**Amendments to the Drawings:**

### REMARKS/ARGUMENTS

Respectfully submitted,  
Rainer AUFISCHER ET AL. - 1 PCT

The attached sheet of drawings includes new FIG. 3 depicting a slide bearing or bearing for reducing friction in accordance with the invention.

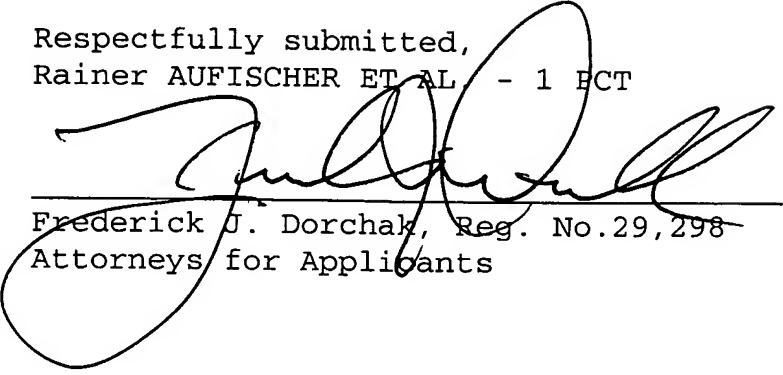
The drawings were objected to under 37 C.F.R. 1.83(a) as failing to show the "bearing surfaces/coatings" recited in the claims. In response, Applicants submit herewith a new FIG. 3, showing the slide bearing or bearing for reducing friction recited in claim 1 as amended, having a metallic support shell 1, on which a slide layer 2 made of a bearing metal is applied and which slide layer 2 carries a cover layer 3, which serves as a running layer and whose thickness corresponds at most to the wear of the cover layer that can be expected during the average useful lifetime of the slide layer 2. The specification has been amended to refer to FIG. 3 and the items shown therein. It is respectfully submitted that the foregoing amendments overcome the

Examiner's objections under 37 C.F.R. 1.83(a), and Applicants respectfully request that the objections on this basis be withdrawn.
